STAFF RECOMMENDATION
1519 Forrest Avenue
April 17, 2019

Application: New Construction—Addition; Partial Demolition
District: Lockeland Springs-East End Neighborhood Conservation Zoning Overlay
Council District: 06
Base Zoning: R6
Map and Parcel Number: 08309035400
Applicant: Lynn Taylor
Project Lead: Melissa Baldock, melissa.baldock@nashville.gov

Description of Project: Application is to construct a rear addition with an attached garage at the basement level. The application also includes removing a non-historic portion of the rear of the house.

Figures 4 & 5 show the rear extension that is to be removed.

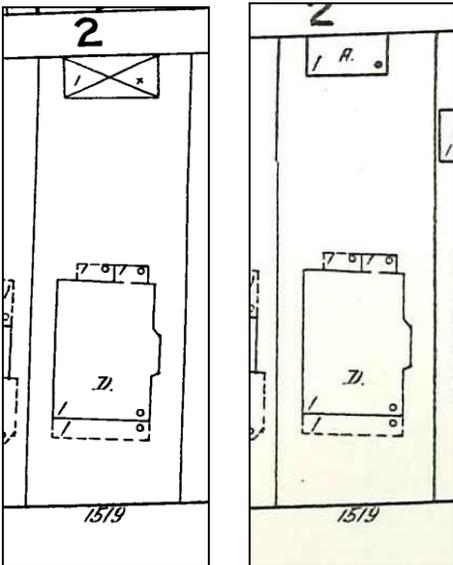
Demolition: At the rear, the applicant intends to remove a rear extension (Figures 4 & 5). This part of the house is shown in the 1914 and 1957 Sanborn maps; on these maps the extension is shown as a covered porch (Figures 6 & 7). Although likely original to the house, covered porches like this one were often not constructed to last near a century. Because they are often not structurally sound, they are typically not highly visible from the street, they are not architecturally distinguished in terms of roof form and materials,

and they have typically been altered to be fully enclosed, the Commission has regularly approved their removal. Staff therefore finds that the removal of the rear extension to be appropriate.

Staff finds that the removal of the rear extension meets Section III.B.2 for appropriate demolition and does not meet section III.B.1 for inappropriate demolition.

SITE PLAN

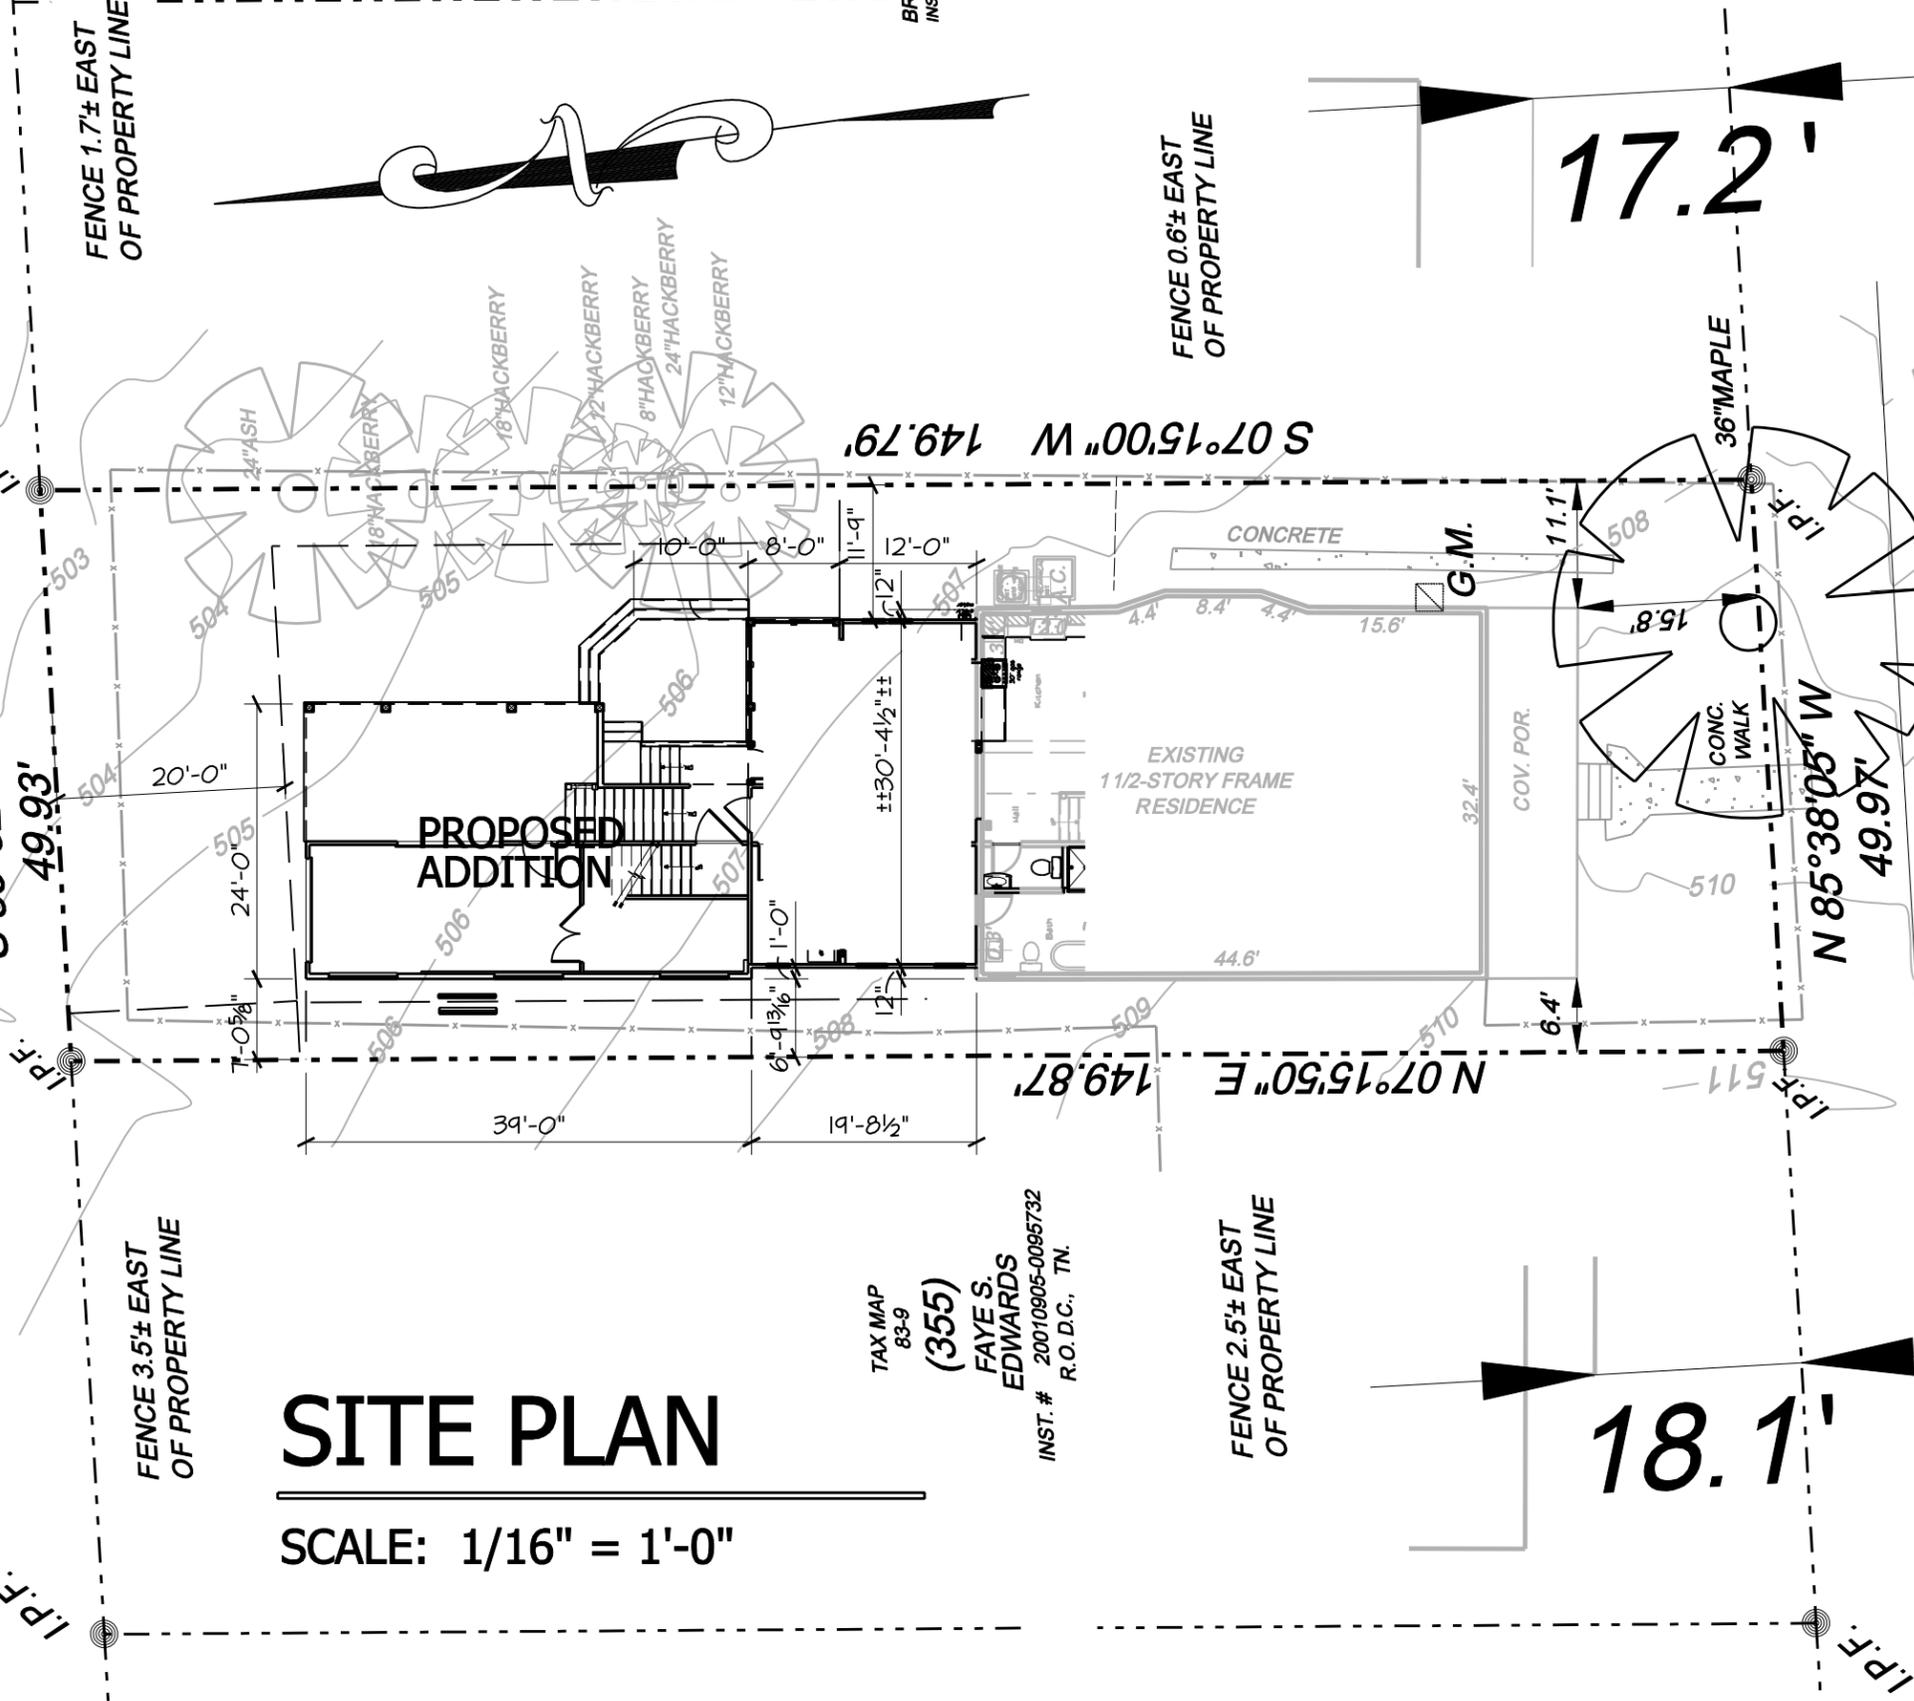
Setback & Rhythm of Spacing: The proposed addition meets all base zoning setbacks. It is at least six feet (6') from the left side property line and eleven feet, nine inches (11'9") from the right side property line. It is approximately twenty-one feet (21') from the rear property line. Because the addition is no wider than the historic house, it will not affect the rhythm of spacing of houses along Forrest Avenue.

Appurtenances & Utilities: No changes to the site's appurtenances were indicated on the drawings. The site plan indicates that the HVAC and utilities will not be moved from their current location at the back of the right façade of the historic house.
